Temperature Screening MinMoe Terminal

Release Notes (2021-04-02)

Device Model: DS-K1T671TM-3XF DS-K1TA70MI-T DS-K5671-3XF DS-K5604A-3XF	Firmware Version	ARM: DS-K1T671TM-3XF, DS-K1TA70MI-T, DS-K5671-3XF/ZU: ACS_671_3XF_AI3_EN_STD_V3.2.2_build210324 ACS_671_3XF_AI3_EN_NEU_V3.2.2_build210324 DS-K5604A-3XF: ACS_5604A_3XF_AI3_EN_STD_V3.2.2_build210323 ACS_5604A_3XF_AI3_EN_NEU_V3.2.2_build210323 MCU: ACS_DS-K1T671_ST1_GML_GM_V1.0.1_build210320 Thermal Module: digicap_thermo-en-gm_V5.5.10_build210316
	SDK	Latest baseline
	iVMS-4200 Version	Latest baseline

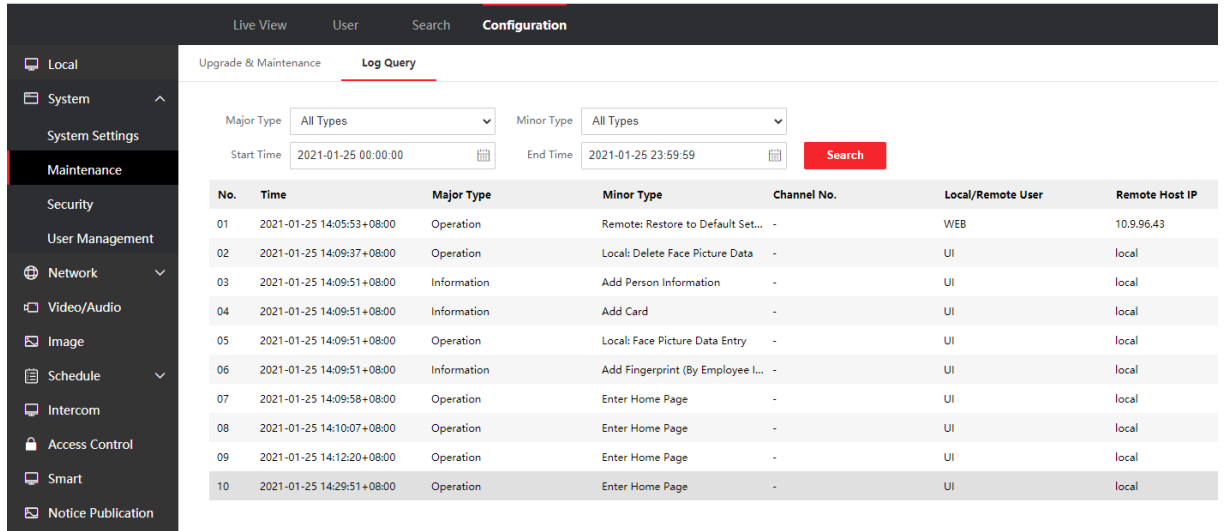
1. Support web interface to login and configure device from browser.
2. Support TTS (English only) self-defined audio prompt for verification (disabled in default).

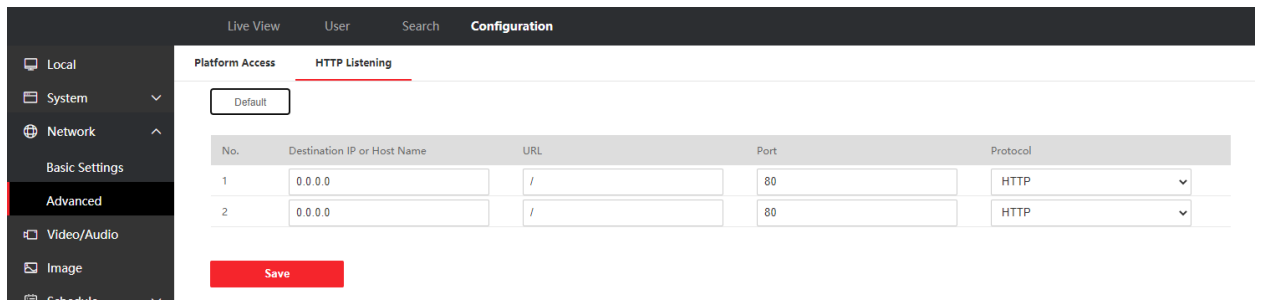
3. Add device operation log query function

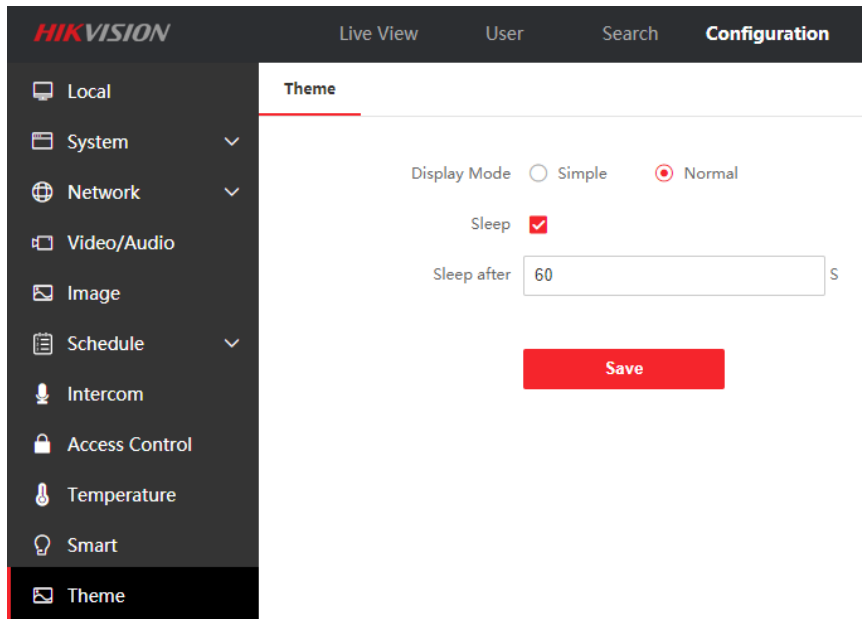
4. Add ISAPI event monitoring upload (HTTP/HTTPS listening) function for integration

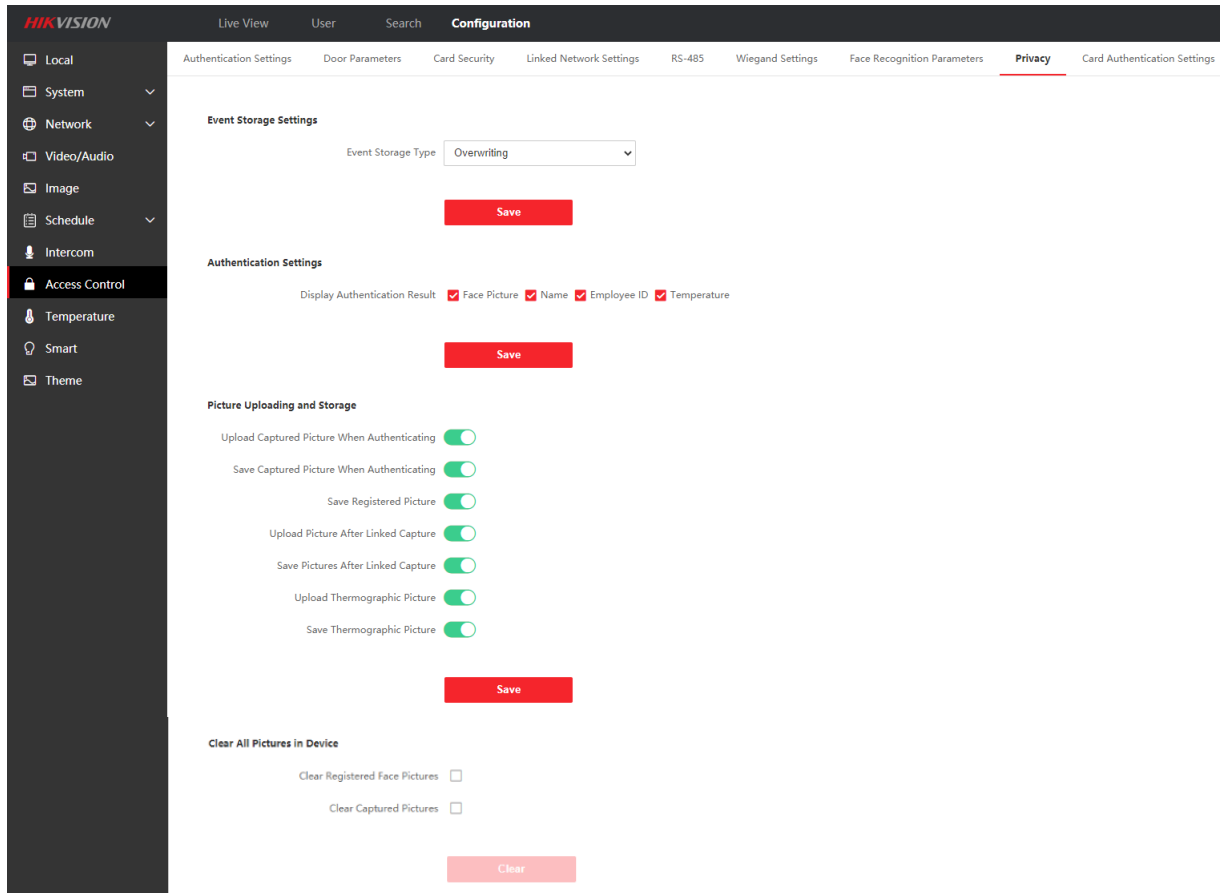
5. Add simple mode (disabled in default), after enable, it will not display live view when verify face

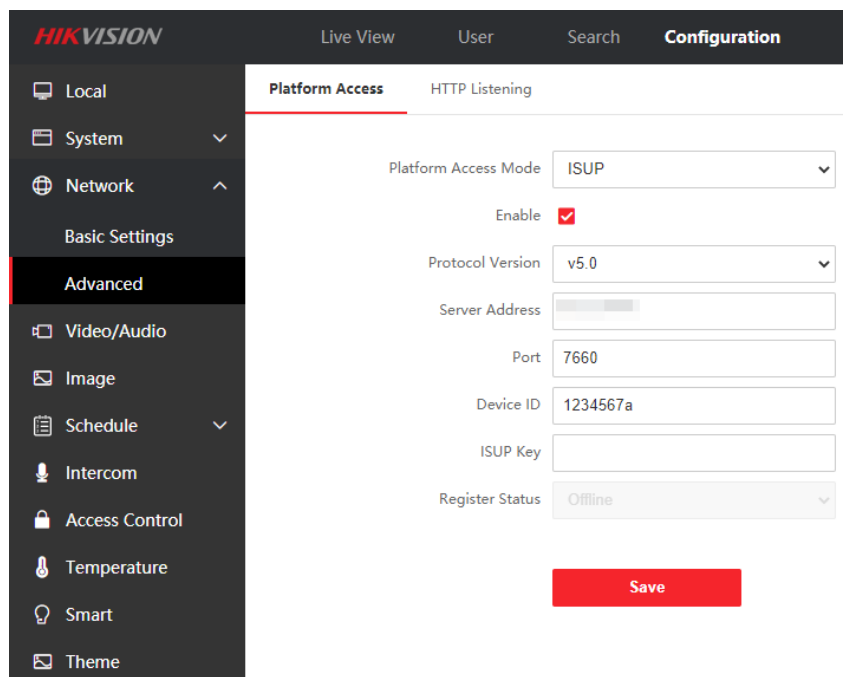
6. Add privacy protection, customer can define the privacy related parameter, such as whether to display photo, name, ID number, temperature after verification, Event Storage Settings, Picture Uploading and Storage, Clear All Pictures in Device

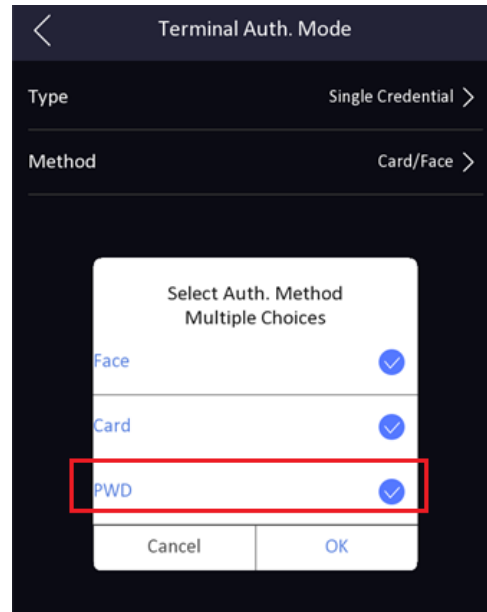
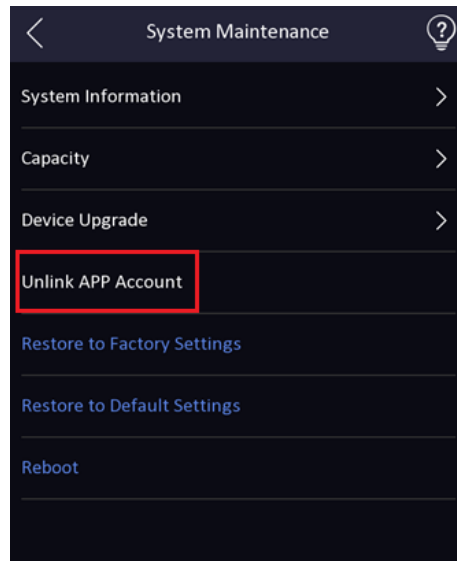
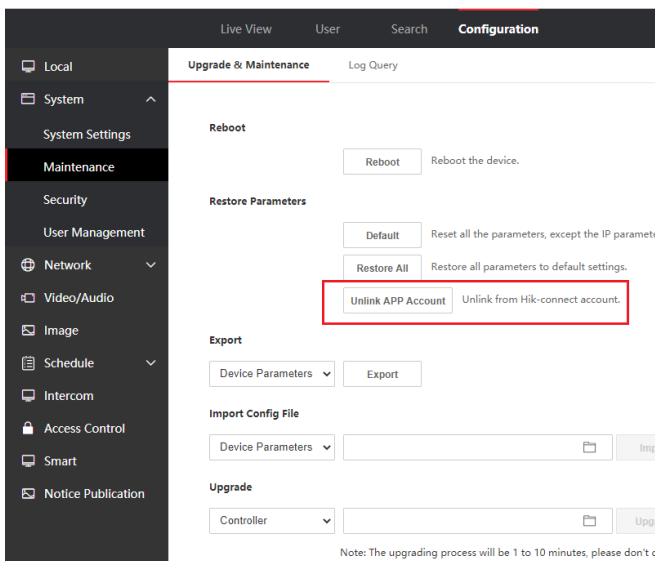
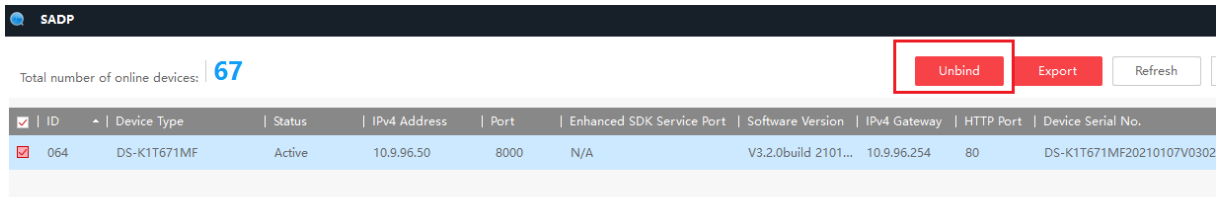
8. Support PIN code only to open the door (disabled in default)

Note : PIN code should be configured from software, iVMS4200 already support, HikCentral Pro will support PIN code configuration in V2.1 expected to be released in June

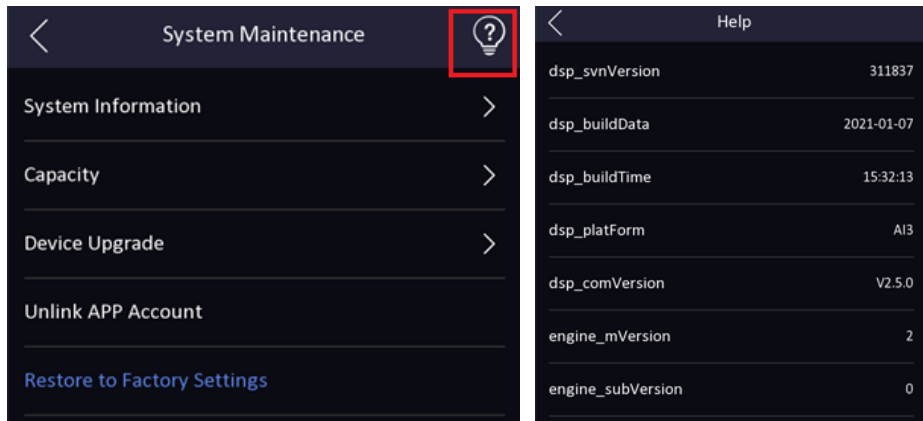
9. Support unbind device with hik-connect account on SADP tool, local UI and web

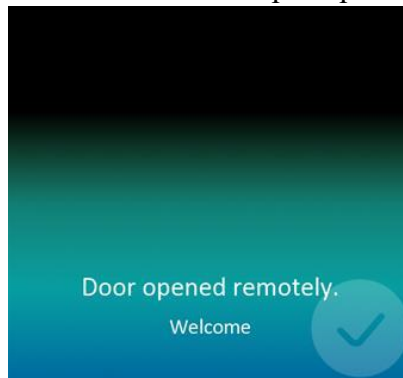
10. Add help interface to check module version for technical support (long press for 3s)

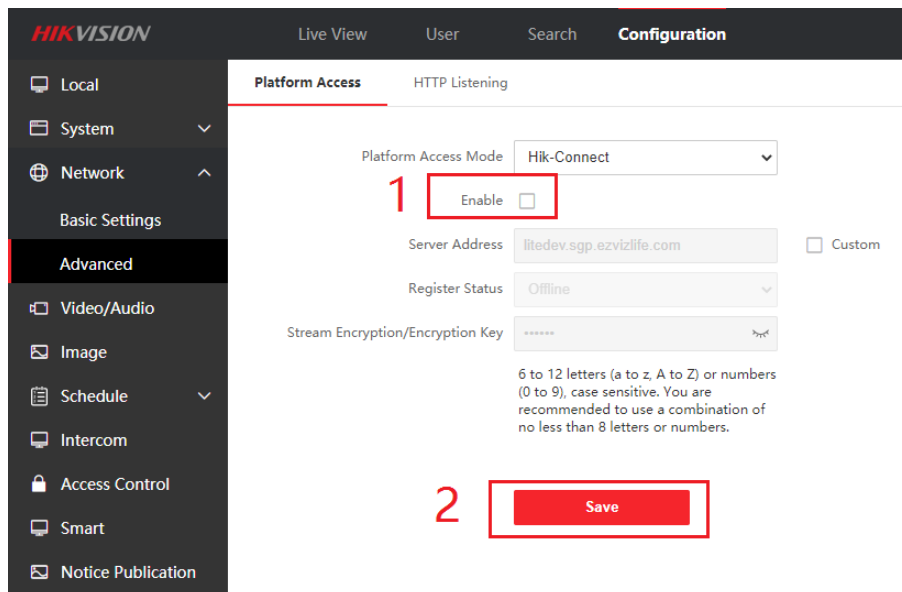
11. Add audio prompt ‘The door is open’ when open door on iVMS4200, HikCentral Pro, Hik-Connect App, and device UI will show prompt

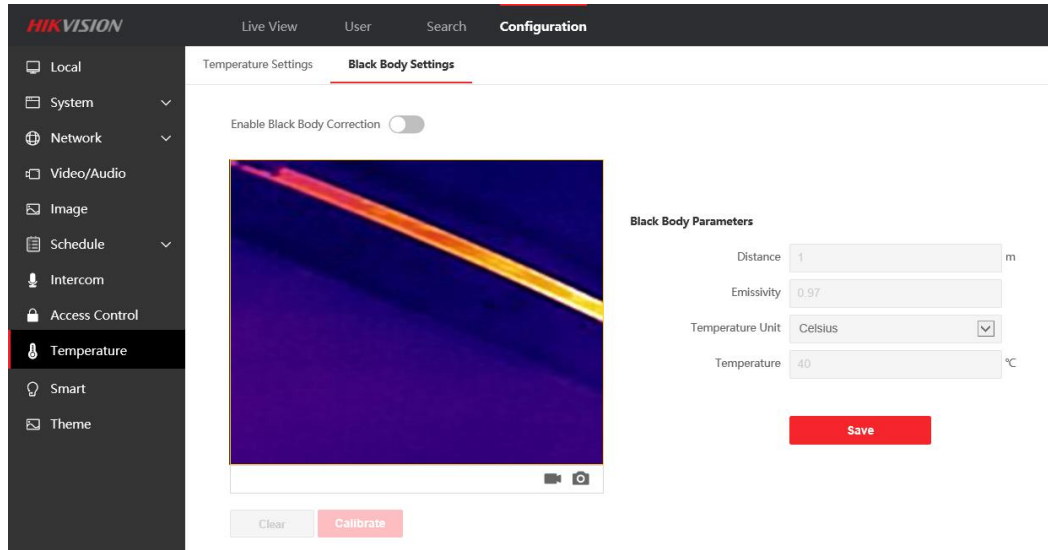
1. Upgrade face and mask algorithm. Improve the speed and accuracy of face and dark mask recognition.
2. Hik-Connect function is disabled in default for privacy protection, if customer want to manage device from App, please turn on manually in the web.

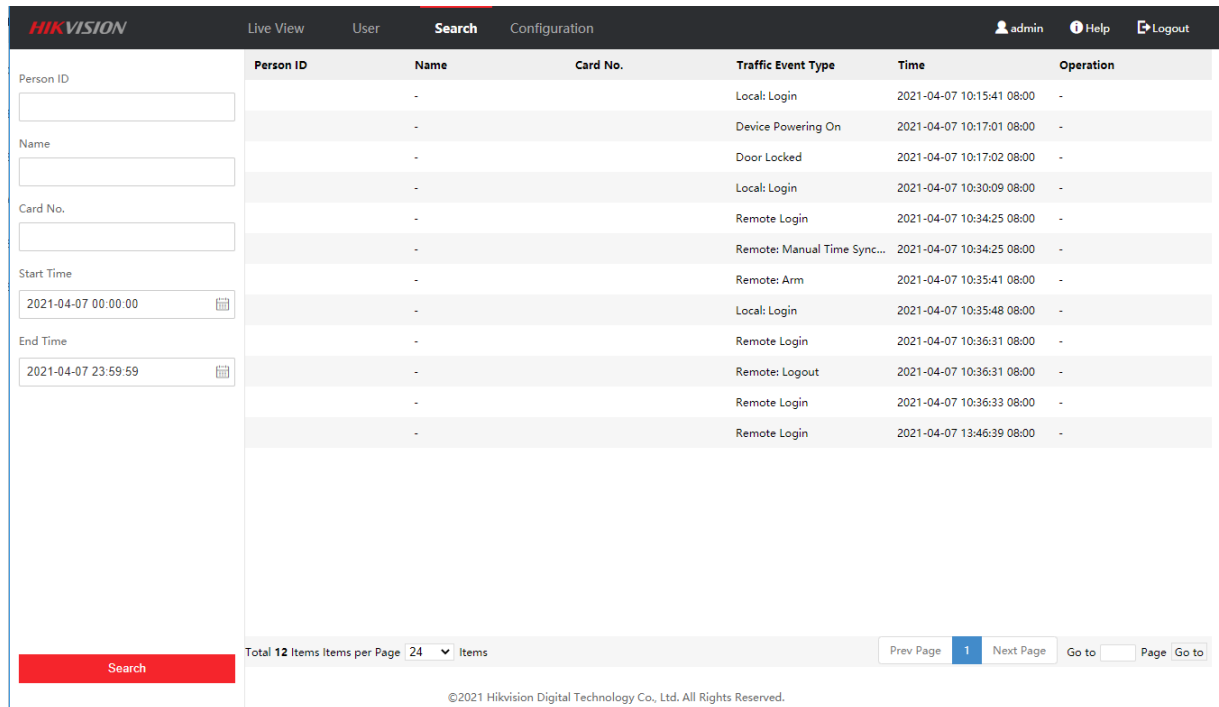
- Black body parameters are deleted from device UI and move to web interface (DS-K1TA70MI-T doesn't support black body function)
